TO: ALL HOLDERS OF OPERATING LICENSES FOR NUCLEAR POWER REACTORS
WITH MARK I CONTAINMENTS

SUBJECT: INSTALLATION OF A HARDENED WETWELL VENT (GENERIC LETTER 89-16)

**REVISED INFORMATION REGARDING PILGRIM STATION
SAFETY ENHANCEMENT PROGRAM**

Section 3.2 Revision 1 "Installation Of A Direct Torus Vent System (DTVS)"

FIGURE 3.2-1

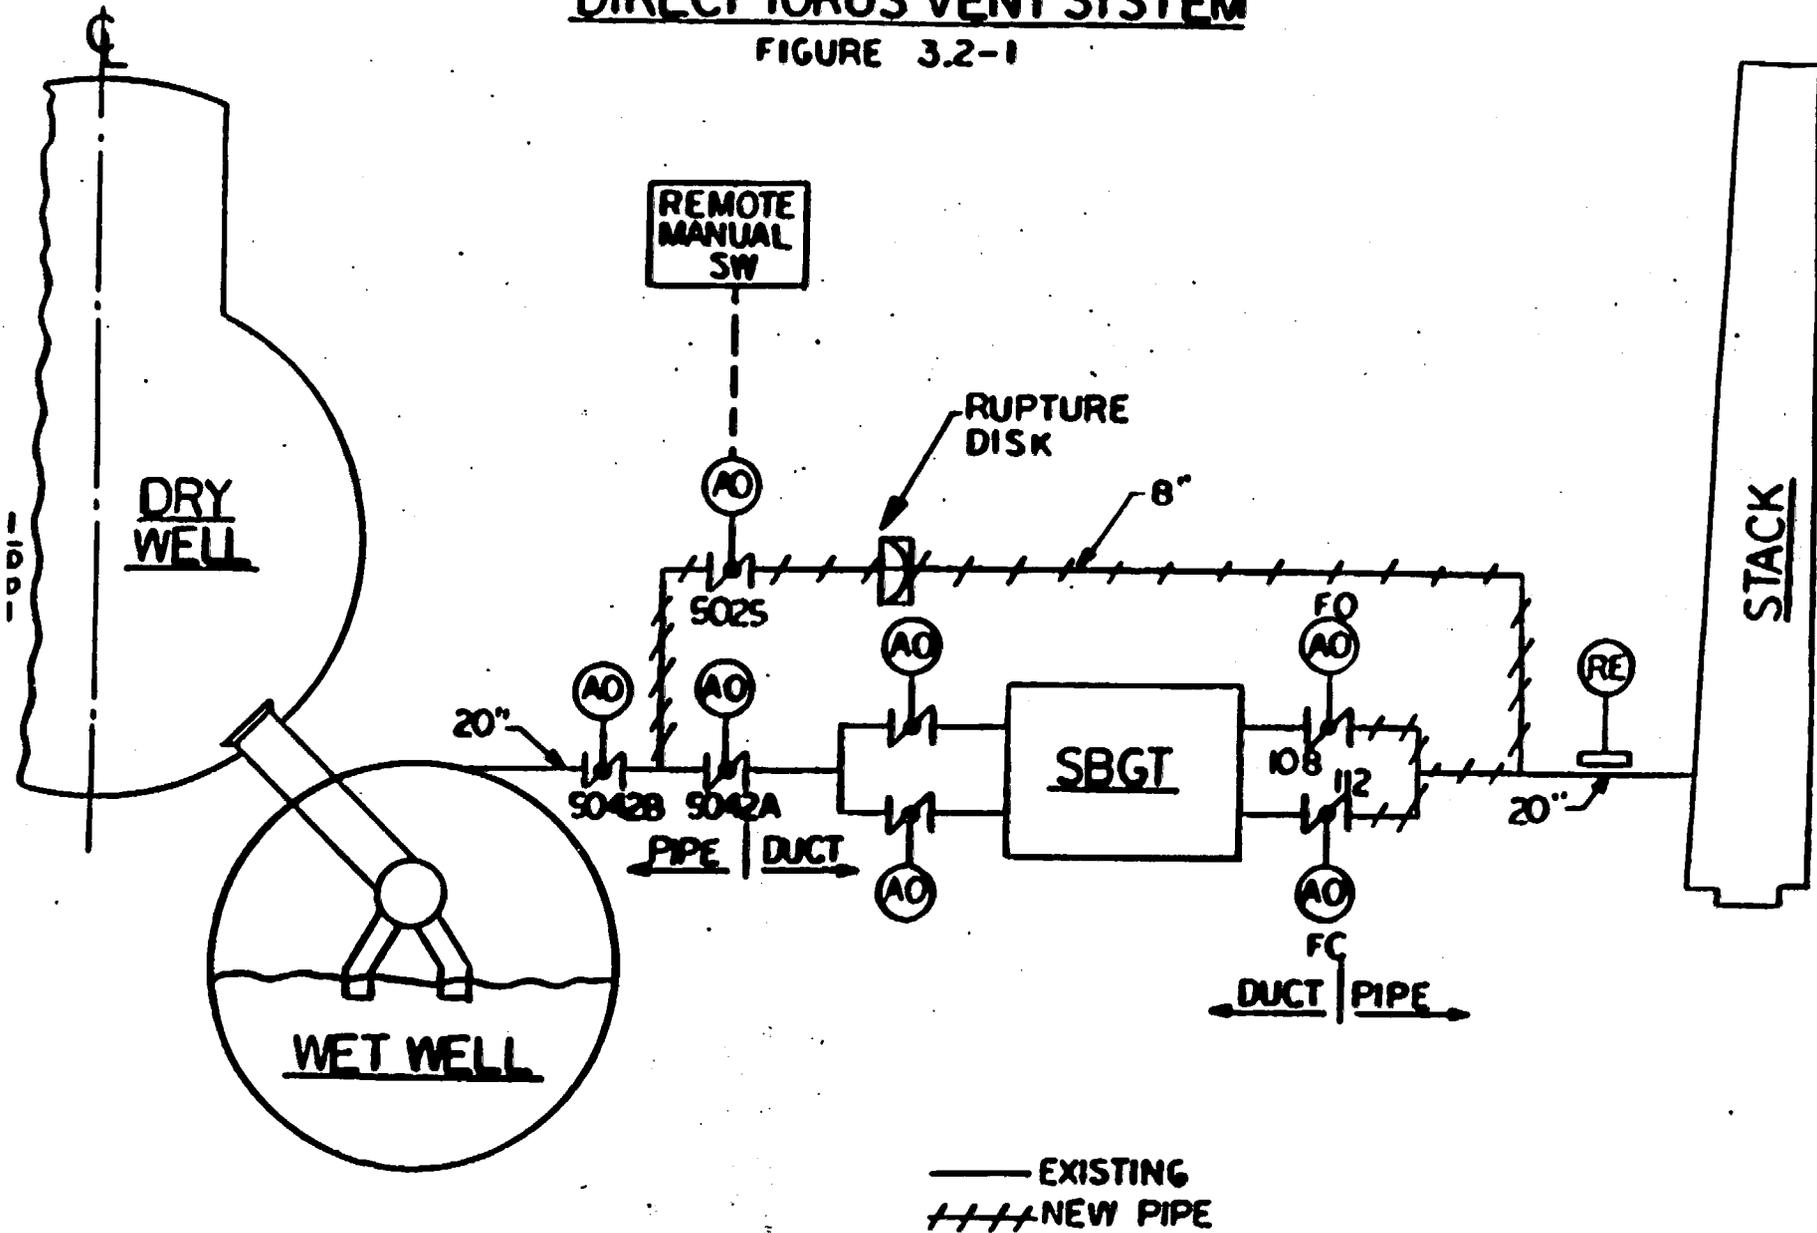
This design change (Figure 3.2-1) provides a direct vent path from the torus to the main stack bypassing the Standby Gas Treatment System (SBGTS). The bypass is an 8" line whose upstream end is connected to the pipe between primary containment isolation valves AO-5042 A & B. The downstream end of the bypass is connected to the 20" main stack line downstream of SBGTS valves AON-108 and AON-112. An 8" butterfly valve (AO-5025), which can be remotely operated from the main control room, is added downstream of 8" valve AO-5042B. This valve acts as the primary containment outboard isolation valve for the direct torus vent line and will conform to NRC requirements for sealed closed isolation valves as defined in NUREG 0800 SRP 6.2.4. The new pipe is ASME III Class 2 up to and inclusive of valve AO-5025. Test connections are provided upstream and downstream of AO-5025.

The design change replaces the existing AC solenoid valve for AO-5042B with a DC solenoid valve (powered from essential 125 volt DC) to ensure operability without dependence on AC power. The new isolation valve, AO-5025, is also provided with a DC solenoid powered from the redundant 125 volt DC source. Both of these valves are normally closed and fail closed on loss of electrical and pneumatic power. One inch nitrogen lines are added to provide nitrogen to valves AO-5042B and AO-5025. New valve AO-5025 will be controlled by a remote manual key-locked control switch. During normal operation, power to the AO-5025 DC solenoid will also be disabled by removal of fuses in the wiring to the solenoid valve. This satisfies NUREG 0800 SRP 6.2.4, Containment Isolation System acceptance criteria for a sealed closed barrier. An additional fuse will be installed and remain in place to power valve status indication for AO-5025 in the main control room.

A 20" pipe will replace the existing 20" diameter duct between SBGTS valves AON-108, AON-112 and the existing 20" pipe to the main stack. The existing 20" diameter duct downstream of AO-5042A is shortened to allow fitup of the new vent line branch connection.

A rupture disk will be included in the 8" piping downstream of valve AO-5025. The rupture disk will provide a second leakage barrier. The rupture disk is designed to open below containment design pressure, but will be intact up to pressures equal to or greater than those which cause an automatic containment isolation during any accident conditions.

The two Primary Containment Isolation Valves (PCIVs) AO-5042B and AO-5025 are placed in series with the rupture disk. No single operator error in valve operation can activate the DTVS. The rupture disk has a rupture pressure above the automatic containment high pressure trip point. Thus, the inboard PCIV (AO-5042B) will receive an automatic isolation prior to disk rupture. The inboard PCIV (AO-5042B) requires physical electrical jumper installation to open at primary containment pressure above the automatic high pressure trip point.
